NFPA Technical Committee on Water Mist Fire Suppression Systems (WAM-AAA)

NFPA 750 PRE-FIRST DRAFT MEETING AGENDA

September -22, 2020

DRAWING N°
SH14_AA

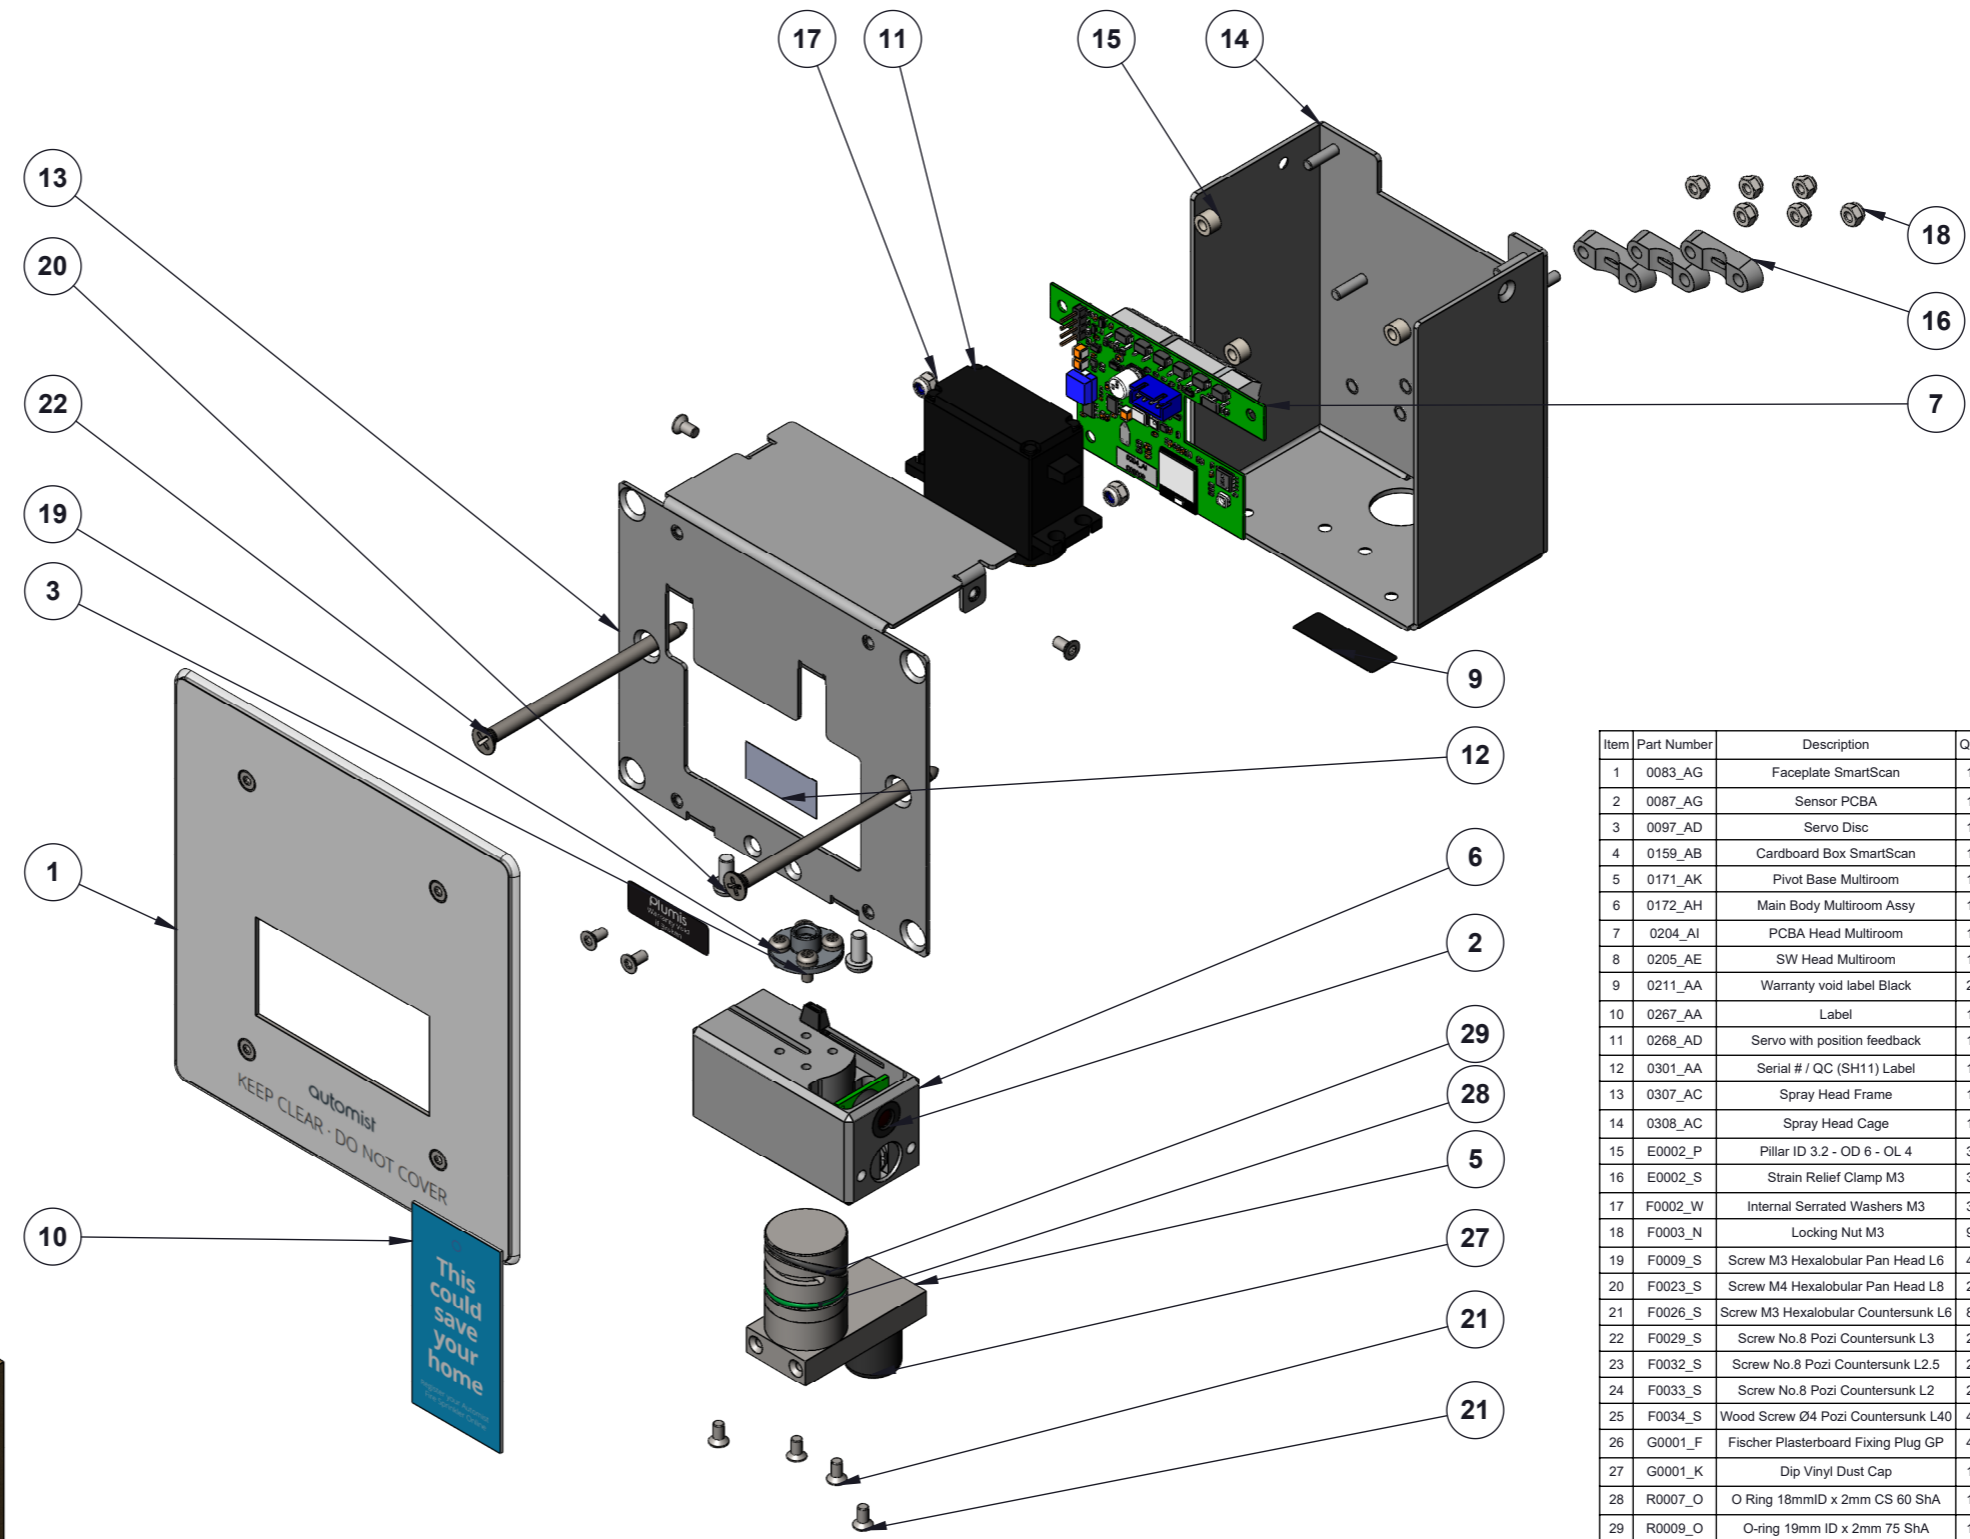
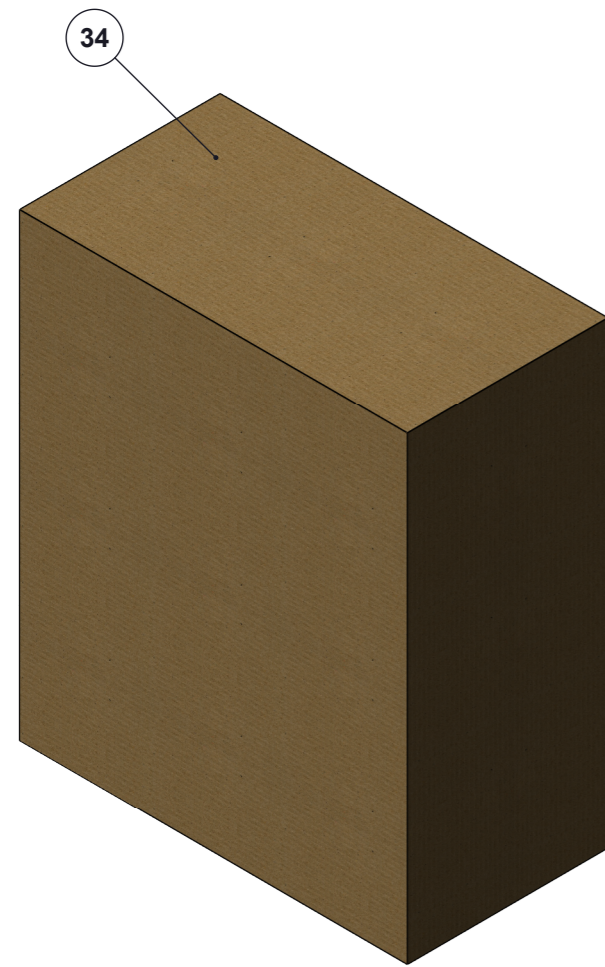
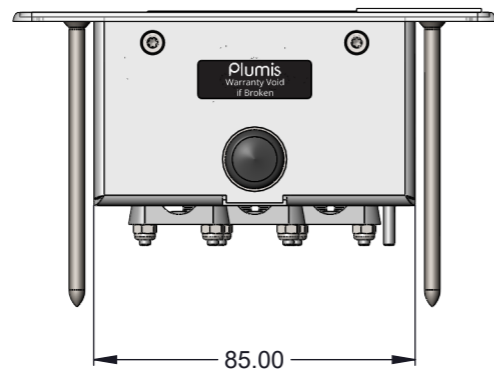
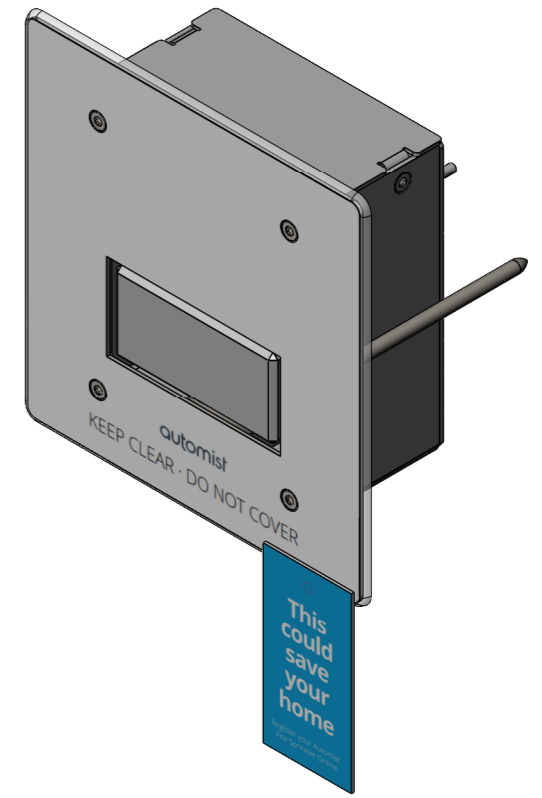
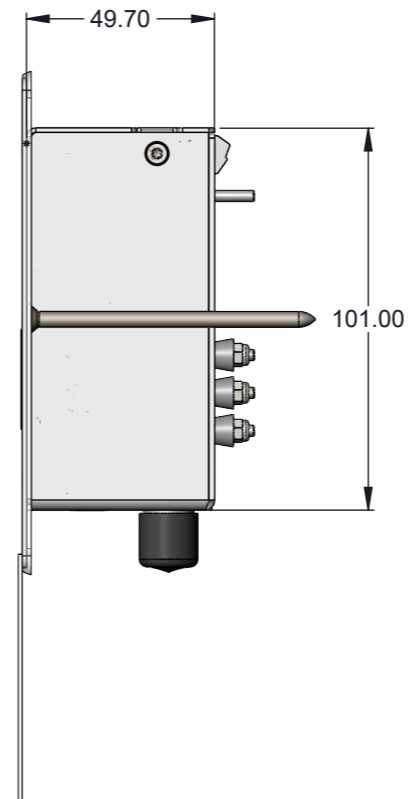
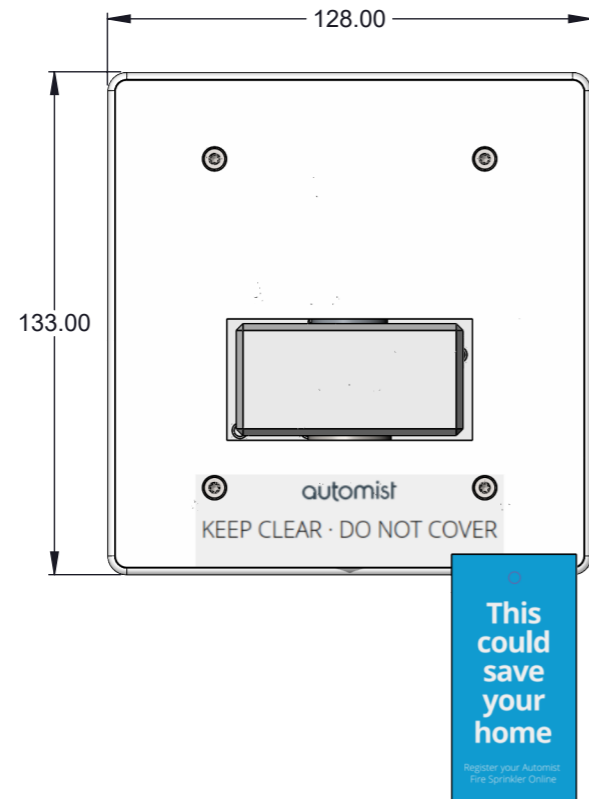
Electronic Automatic Nozzle

A nozzle which release of water is made automatically by electronic means instead of by mechanical means.

| <u>File Name</u> | <u>Description</u> | <u>Approved</u> |
|--|--|-----------------|
| SH14_AA_Multiroom_Spray_Head_Rev.01.PDF | Automist Hydra Spray head exploded view: electronic nozzle | |

We manufacture a nozzle which electronically determines the fire location (using a thermopile sensor) and which also controls whether it is open or closed (using a servo motor controlled valve). This nozzle does fall within the existing definitions in NFPA 750. The proposed definitions are attempts at suggesting a definition for NFPA 750 which is also futureproof for other variations on the theme. Details of our product can be found on our website: www.plumis.com. Videos of the system in operation can be found at: <https://www.youtube.com/user/PlumisAutomist>.

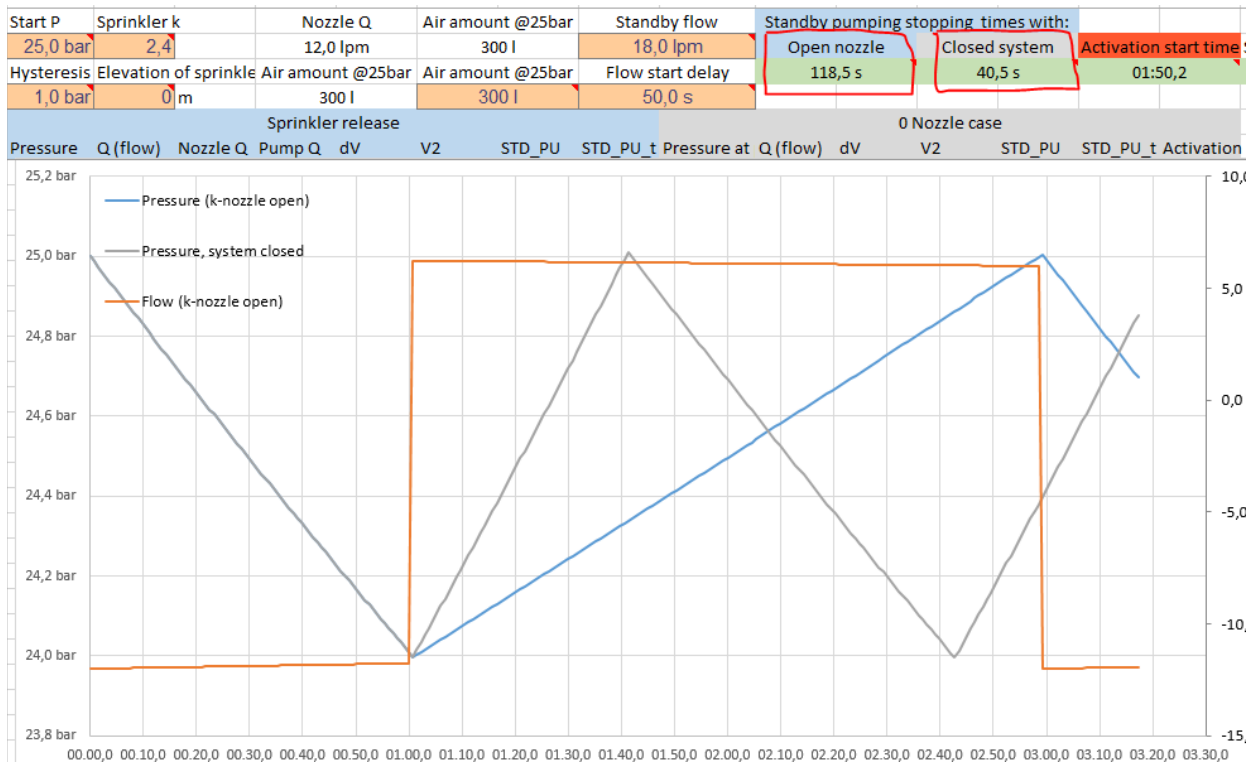
For large systems with lots of air, pressure maintenance pump shall be allowed to provide more flow. Even more than 100% of smallest nozzle flow at standby pressure.

Time for standby pump to elevate pressure to stop limit when there is one small nozzle discharged.

When the allowed standby pumping time is set to e.g. 70 seconds, which is too long time for detecting a real need for pump operation. With 100% flow, there cannot be any false stops (as it takes hours to stop unintentionally) but the operational response as weak.

In case the standby pump flow in case #2 would be 150% of the nozzle flow, we'll have following times:
Time for standby pump to elevate pressure to stop limit when there is no discharged nozzles.

Figure 1 - design per NFPA 20

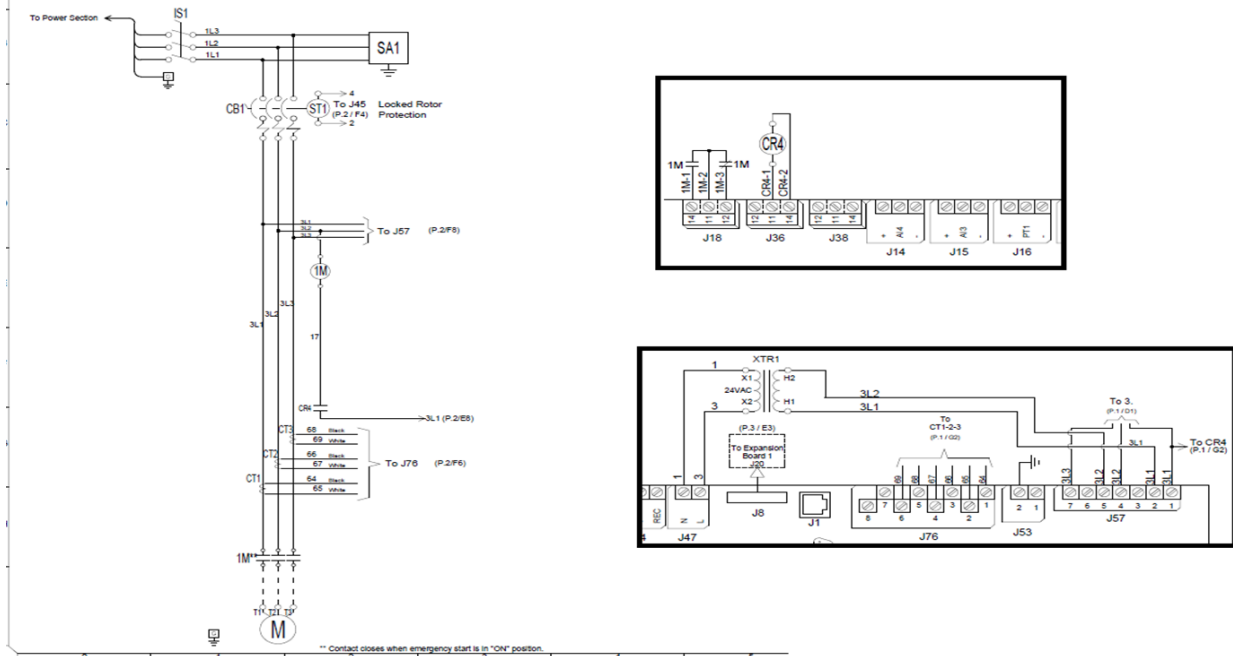
Design study of one manufacturer that is FM approved, UL listed and the design is per NFPA 20. Schematic shown below in Figure 1.

Figure 2 - Common Marioff motor control circuit

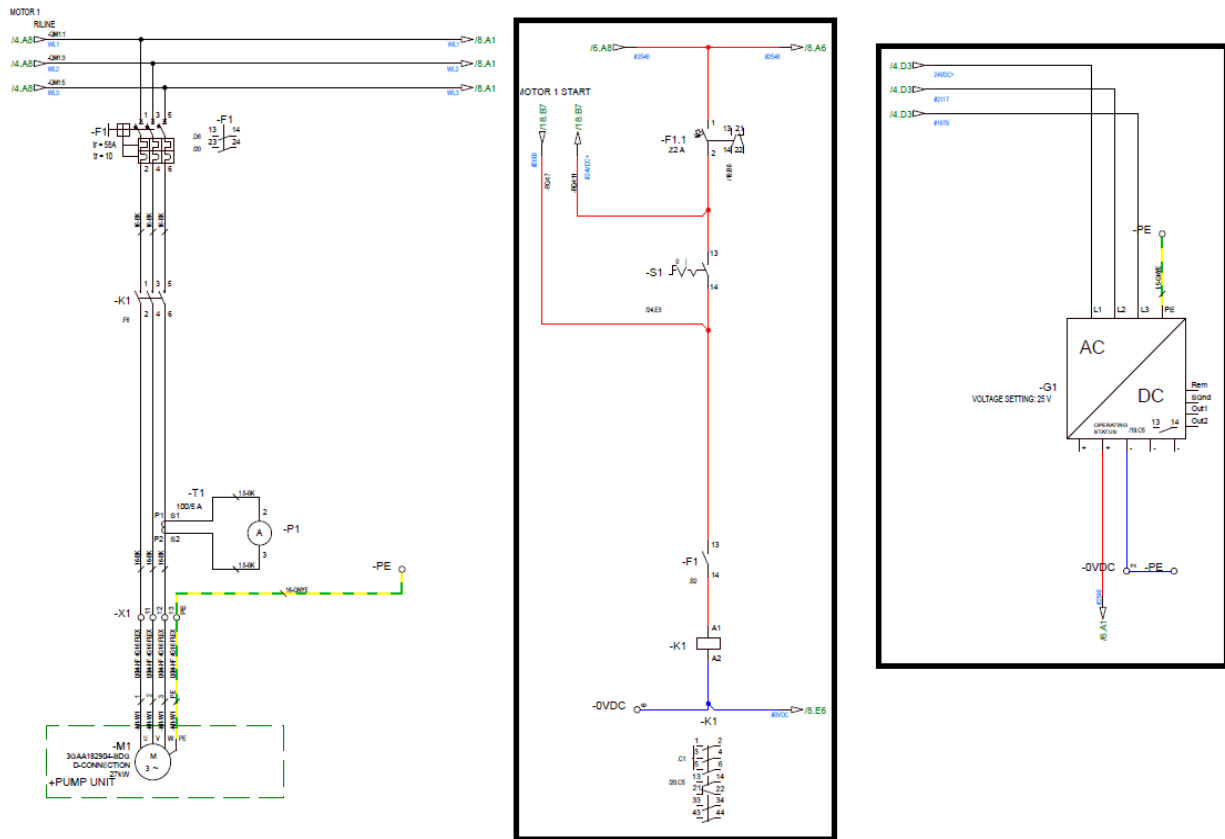
From reliability perspective to have contactor coil using the same voltage e.g. 24 VDC as the control components are using, would reduce the count of failure points. This is the list of possibly failing components in common Marioff design where 24 VDC is used for contactor coil, according to Figure 2:

- Contactor coil (K1)
- Transformer (G1) (in multi pump units the transformer failure would disable all pumps). Thus each motor control circuit needs to be isolated with a circuit breaker to protect power supply to remaining motor control circuits and redundant transformer is recommended for multi pump systems.
- Latching switch (S1) AND [I/O board (RQ3) OR Programmable Logic Controller]
